ADDENDUM No. 3

RFP NO.: 616-008

PROJECT TITLE: Physical Education Building
 Exterior Renovations
 Germantown Campus

Item 3-1: Changes were made to the Construction Documents in response to architectural life safety and electrical review comments received from the Montgomery County Department of Permitting Services (MCDPS). Revised drawings are being reissued in their entirety in response to these comments and are attached to this addendum. Revisions are clouded, noted as “Permit Response Set” and dated 2/22/2016 in the title block on each sheet accordingly.

G002

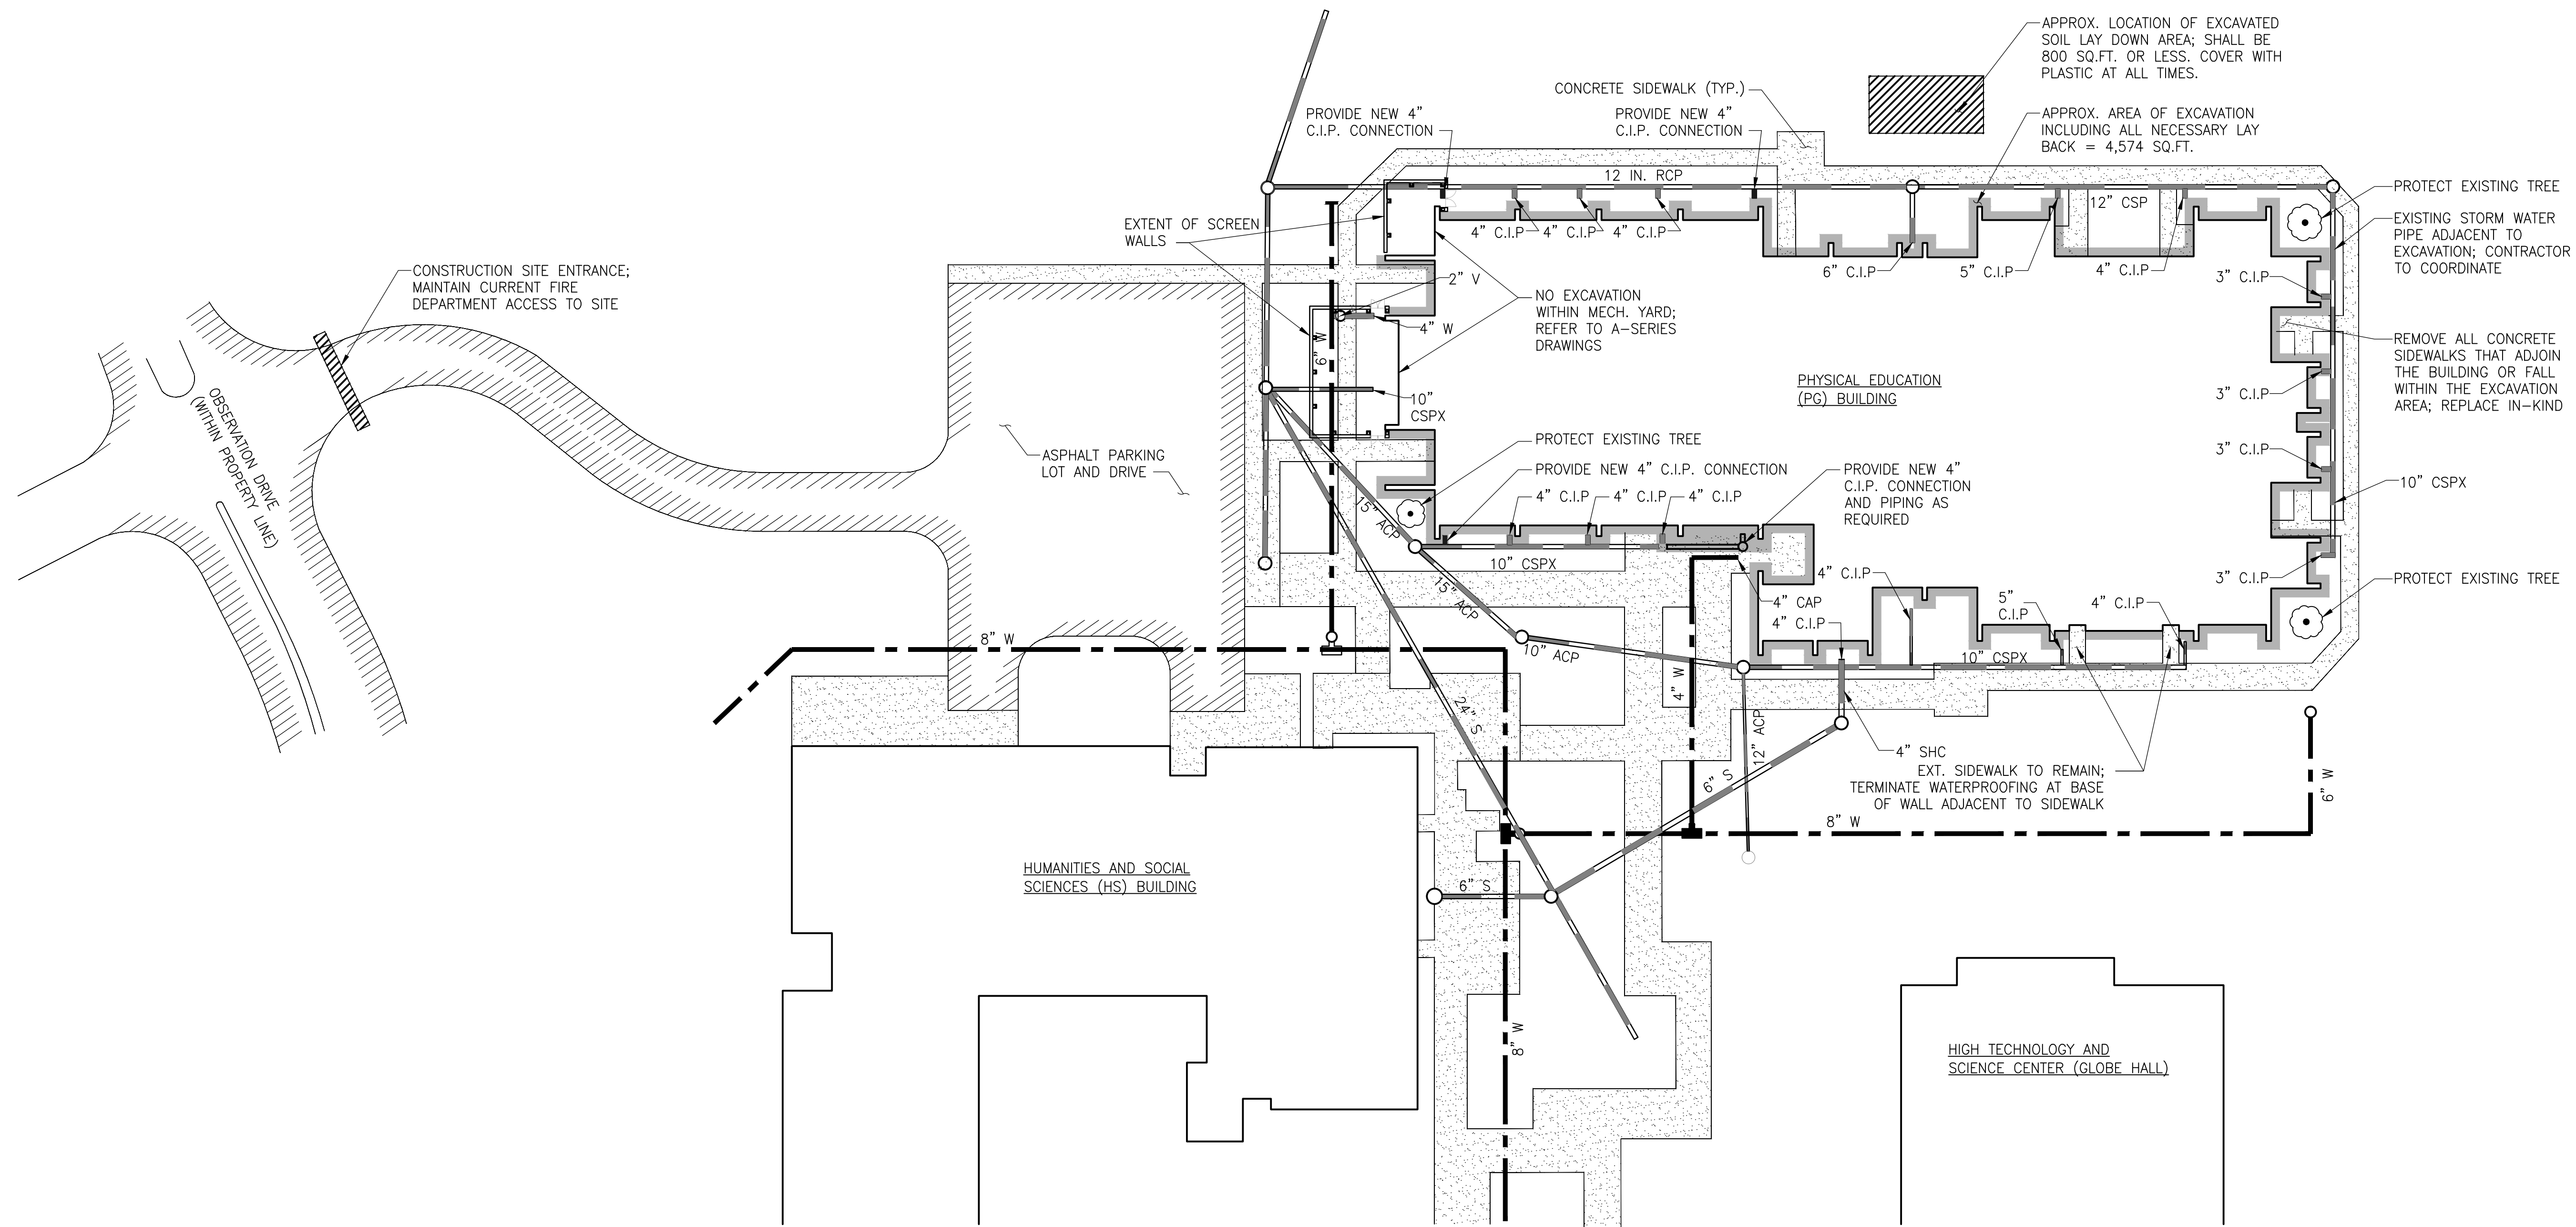
- **Comment #1 (G002):** We revised the Occupancy Group to A-3 (Assembly Group) in Existing Building Information Note 2 per IBC 303.4. See revised Existing Building Information Note 2 on Sheet G002.

- **Comment #2 (G002):** We revised the building height to reflect the number of stories (one story with double-heightened space) and no basement in Existing Building Information Note 4. See revised Existing Building Information Note 4 on Sheet G002.

- **Comment #3 (G002):** We added NFPA 1 (2012), International Fire Code (IFC) 2012, 2010 ADA Standards for Accessible Design, and NFPA 241 to Applicable Building Code Note 1. See revised Applicable Building Code Note 1 on Sheet G002.

- **Comment #5 (G002):** We added Notes 11, 12, 13, 14, 15, and 16 to Staging, Protection and Site Safety Requirements on Sheet G002 that say the following, respectively:

AD100

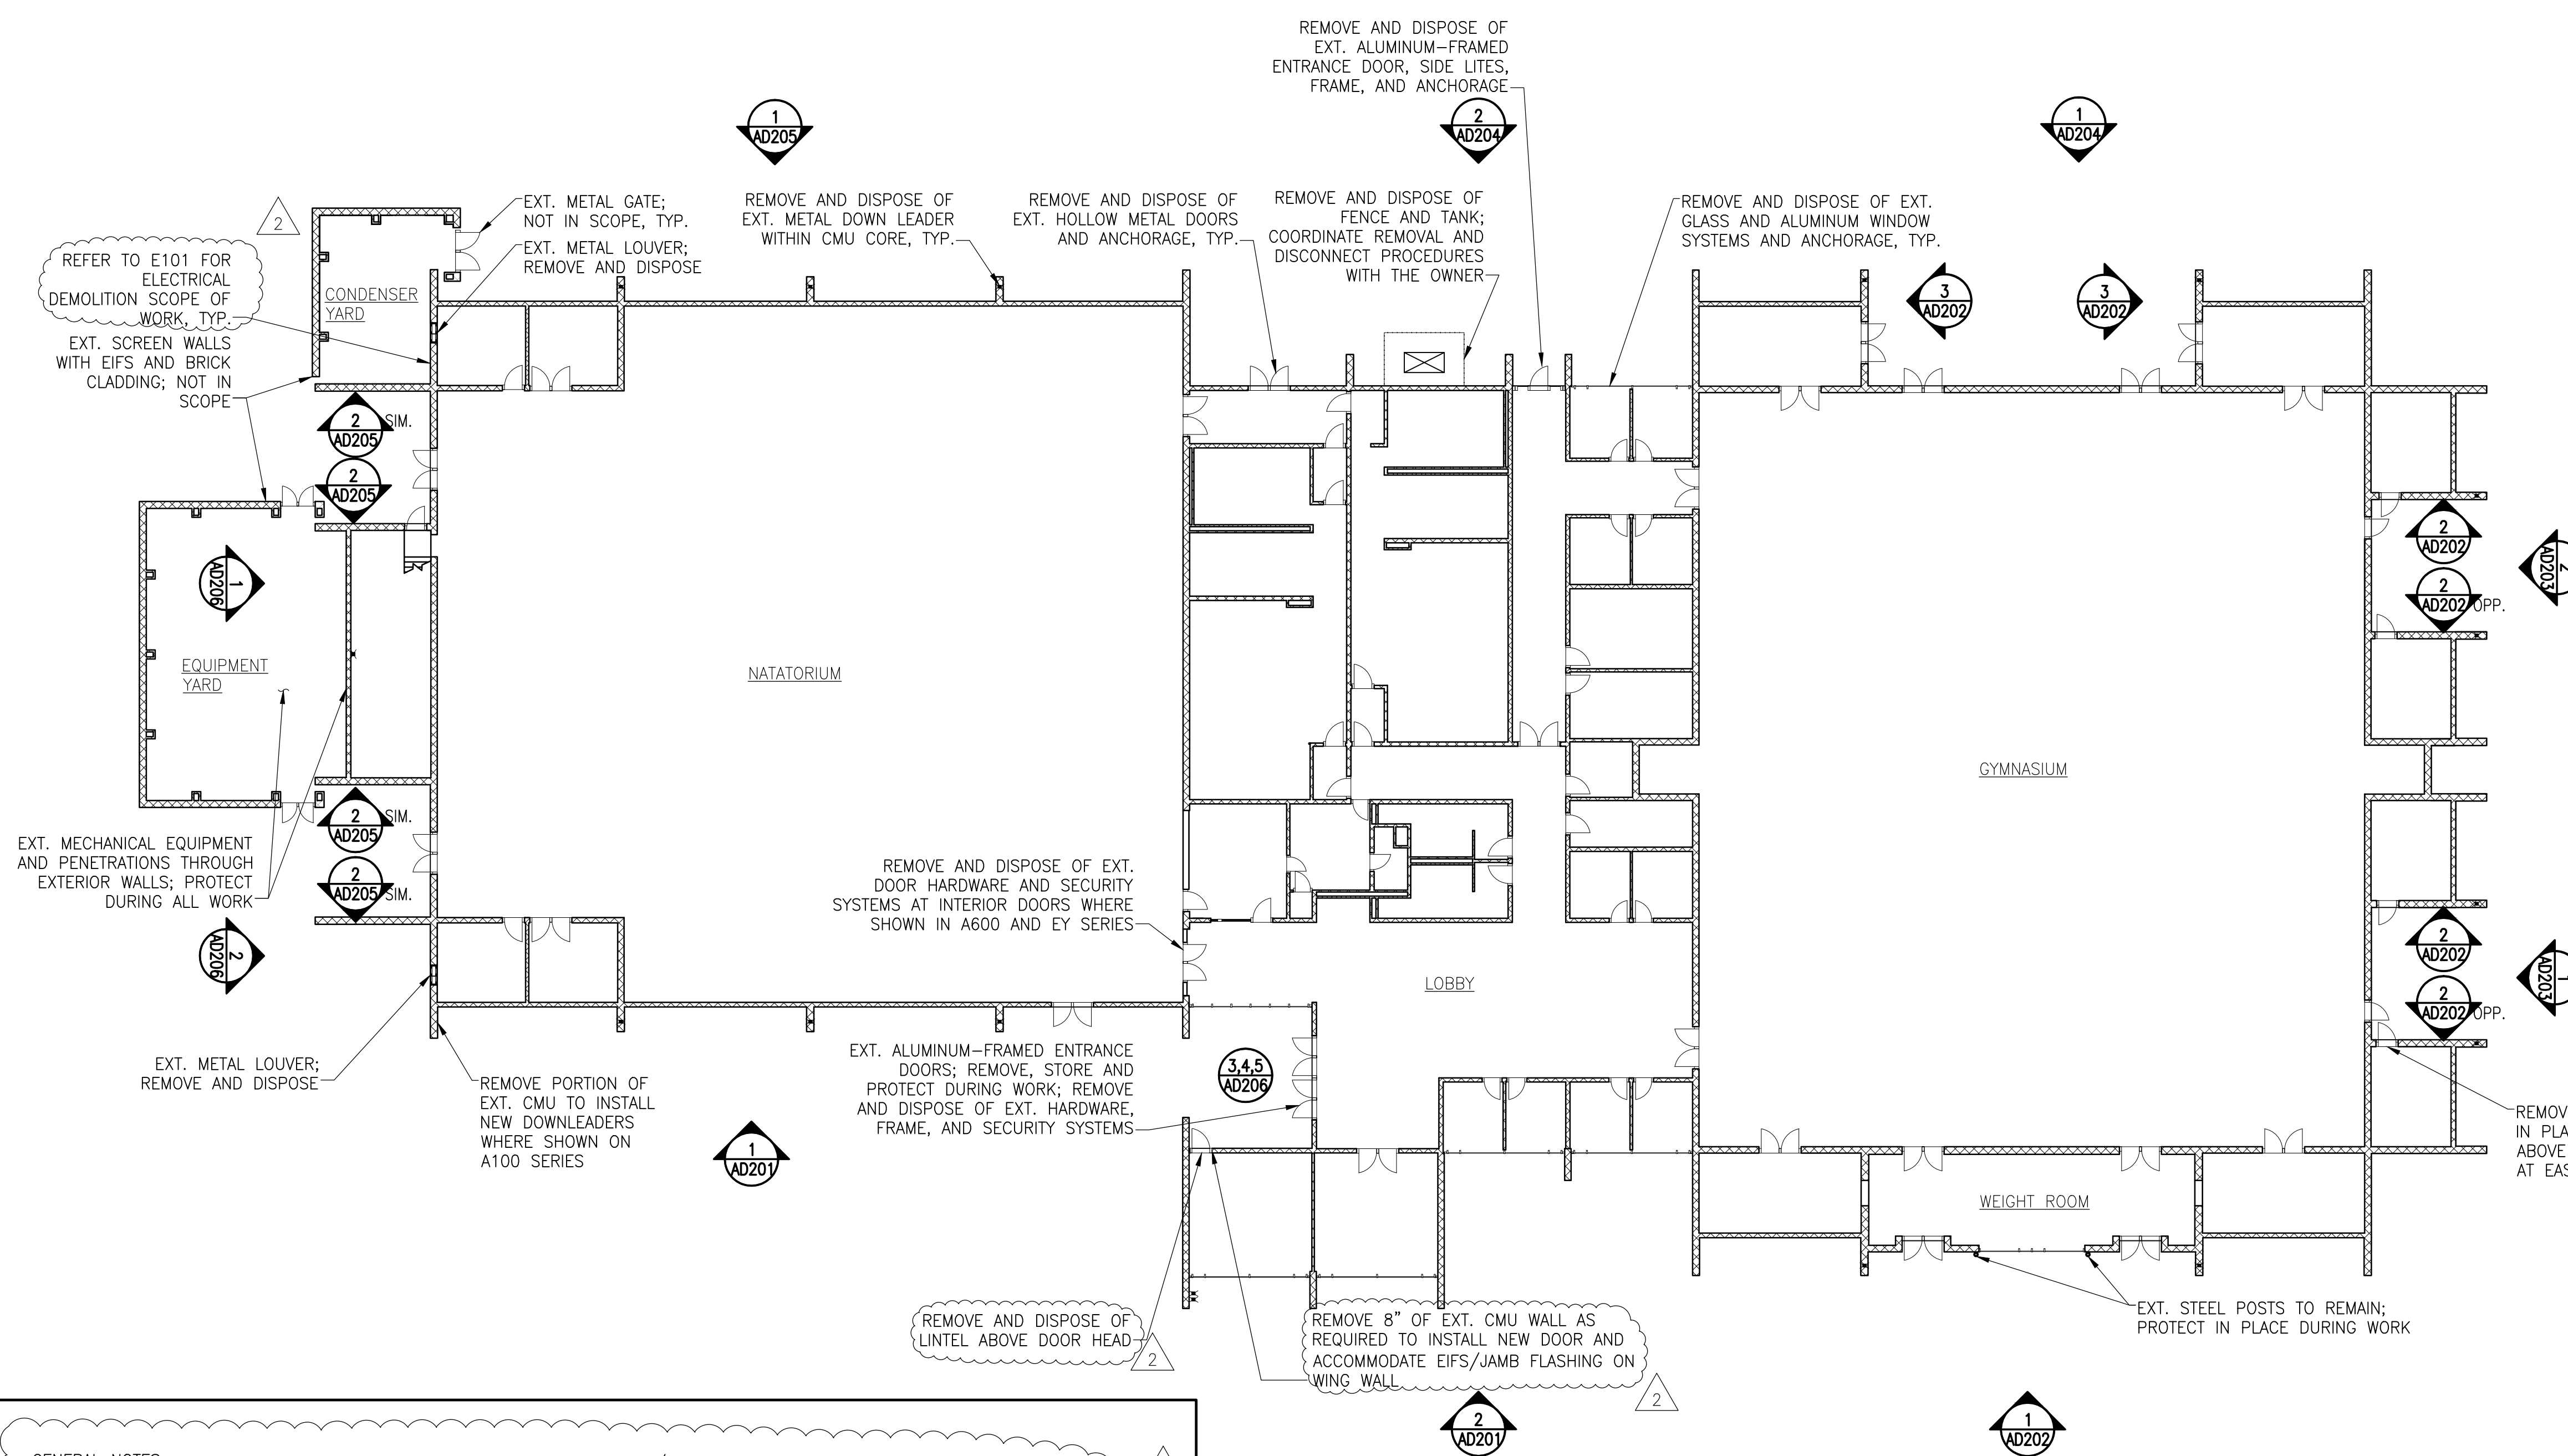
- **Comment #4 (AD100):** We added a "General Notes" and "Building/Sequence of Work" section to indicate the renovation will be done in phases based on when the building will be unoccupied, partially occupied, and fully occupied during construction. We added General Note 3 to indicate the automatic sprinkler system and fire alarm system will remain operational during the renovation. See General Notes 1, 2, and 3, and the Building/Sequence of Work on Sheet AD100.

- Sheet AD100: Added Note 7 to the General Scope of Work This Drawing, saying openings at removed exterior doors serving as exit doors must be maintained for appropriate egress, replacement doors must have appropriate panic hardware in accordance with IBC Section 1010.1.9.9 and Section 1010.1.10, as shown on A600.

- Comment #8 (AD100): We added General Note 1 on Sheet AD100 regarding exterior lighting at exit doors indicating the following:
 - “Floors and other walking surfaces within an exit and within the portions of the exit access and exit discharge, designated in IBC Section 7.8.1.1 shall be illuminated as follows:

- Remove and dispose of the existing door hardware and security systems at interior doors where shown in A600 and EY Series.
 - Openings at removed exterior doors serving as exit doors must be maintained for appropriate egress; replacement doors must have appropriate panic hardware in accordance with IBC Section 1010.1.9.9 and Section 1010.1.10, as shown on A600.

Drawing No.
A101

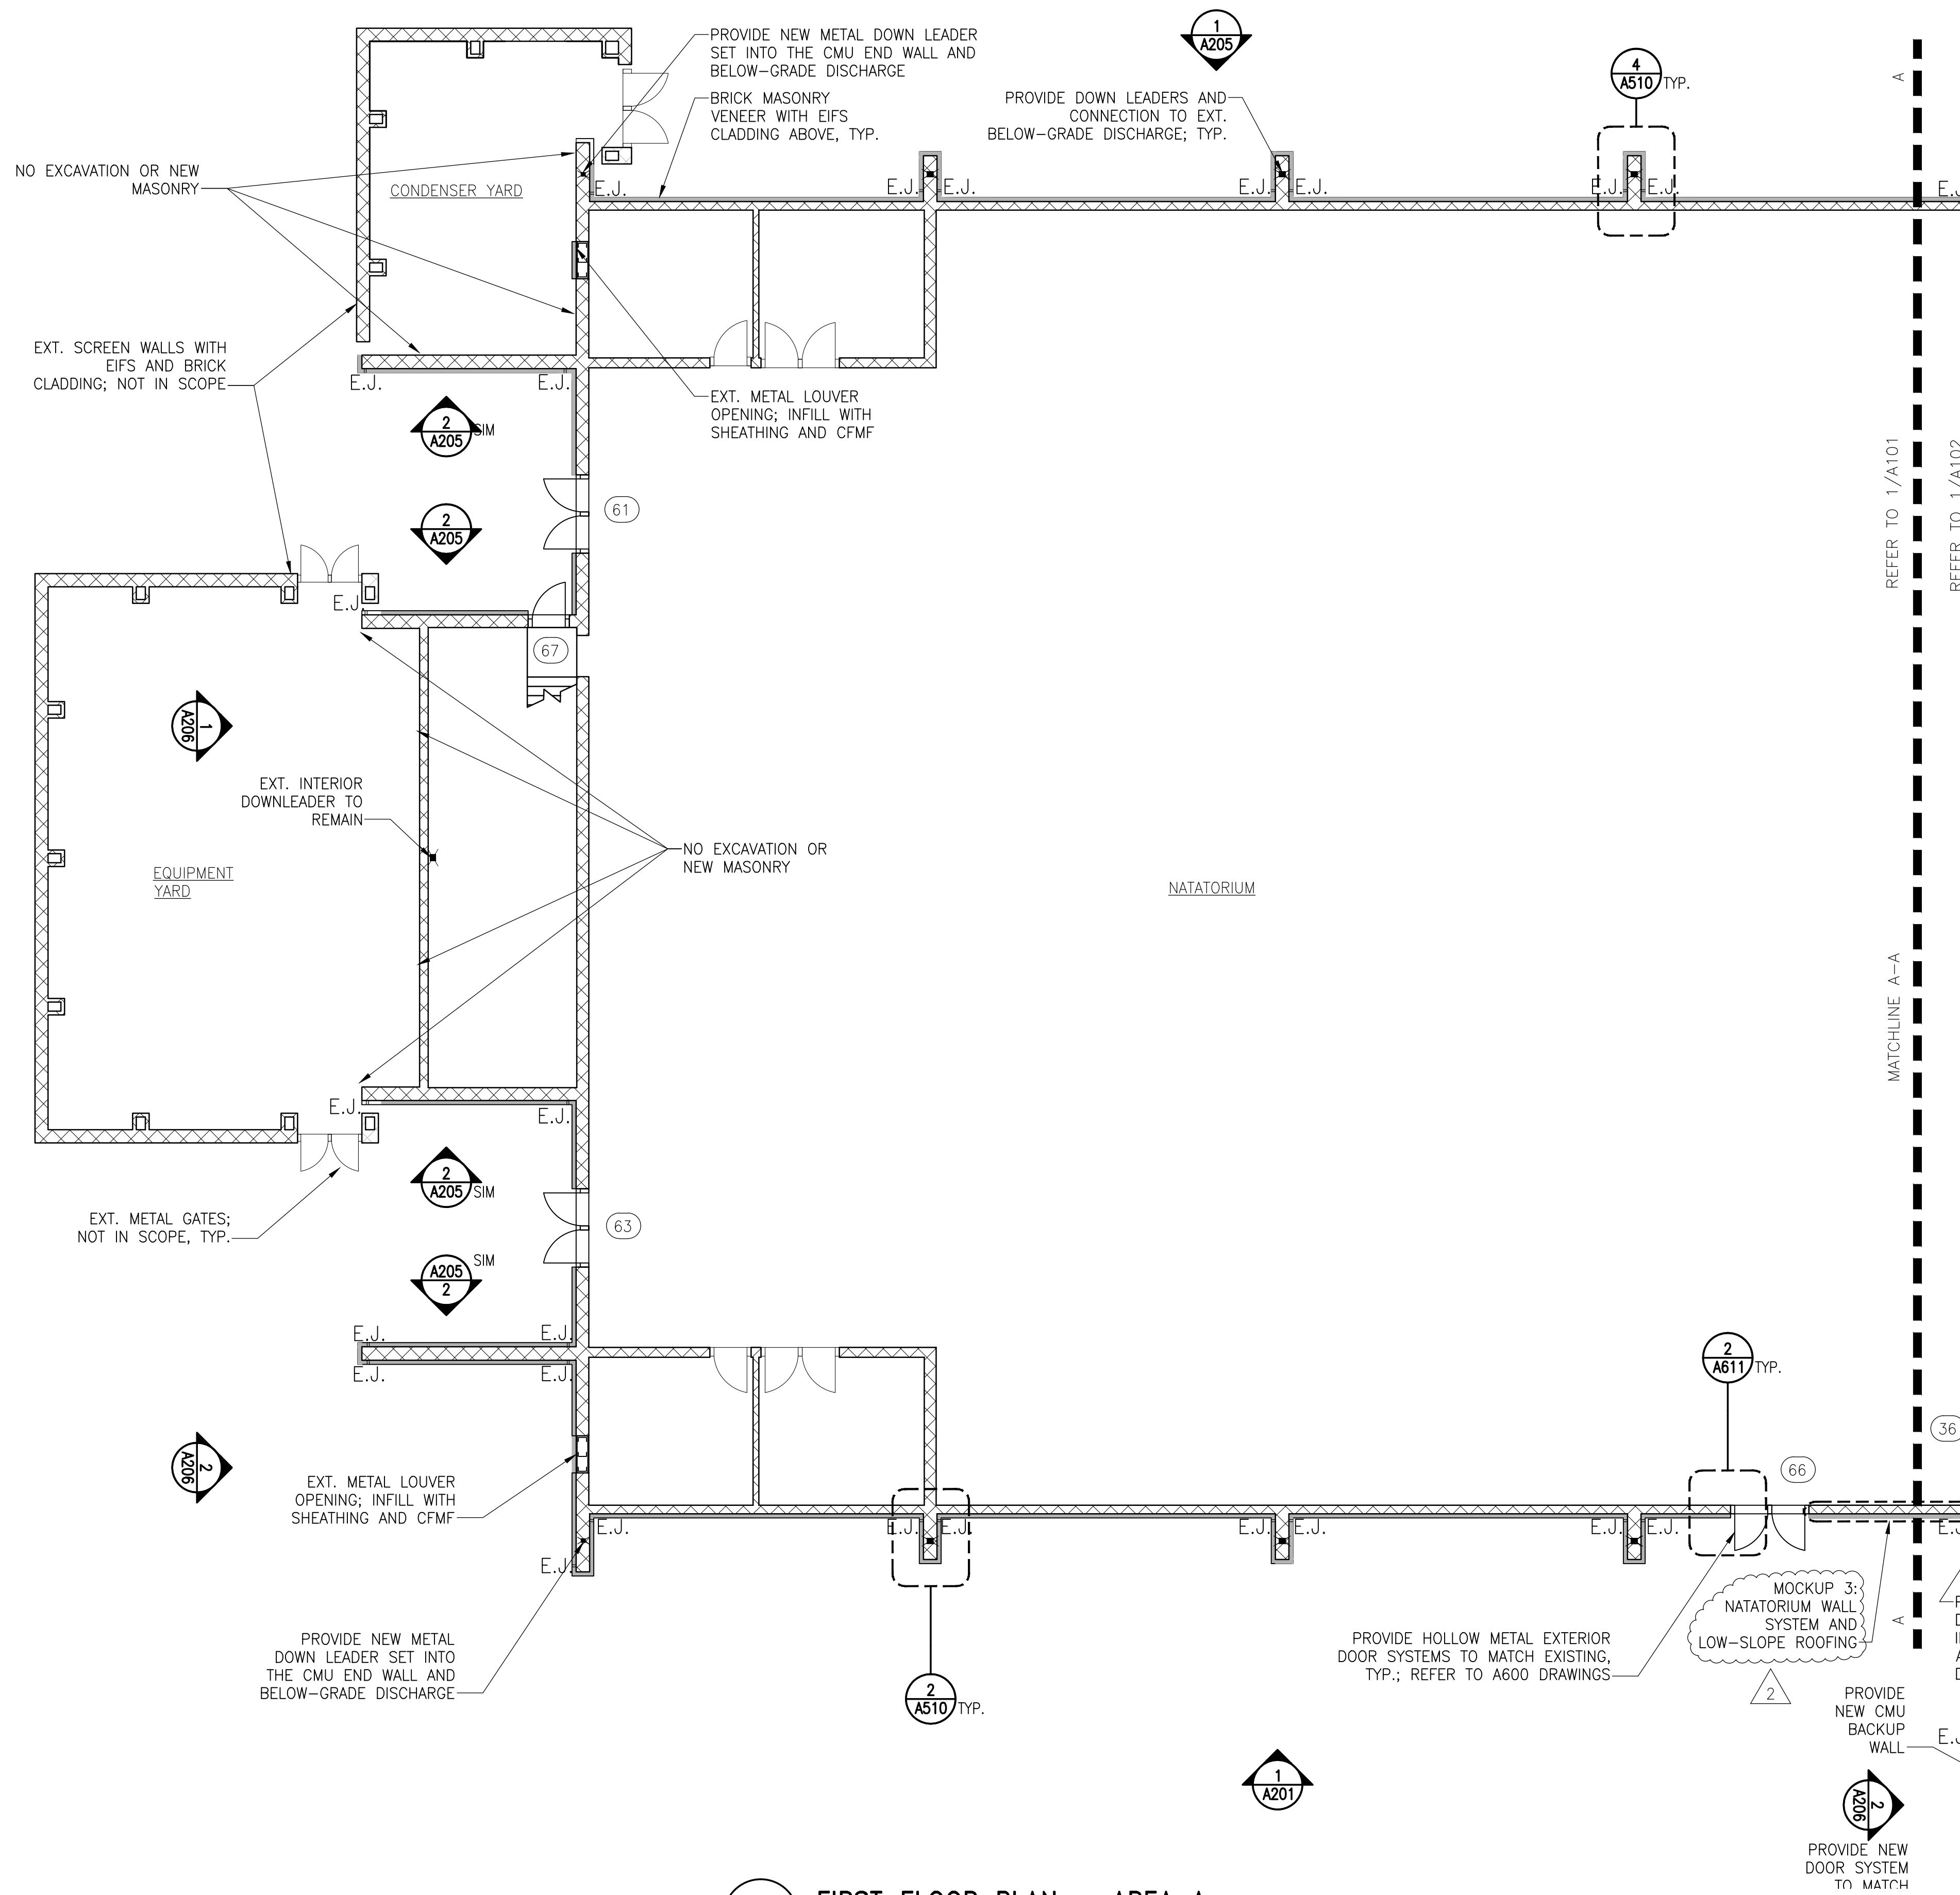
- Sheets A101, A102, A103: Added Note 22 to the General Scope of Work This Drawing, saying openings at removed exterior doors serving as exit doors must be maintained for appropriate egress, replacement doors must have appropriate panic hardware in accordance with IBC Section 1010.1.9.9 and Section 1010.1.10, as shown on A600.
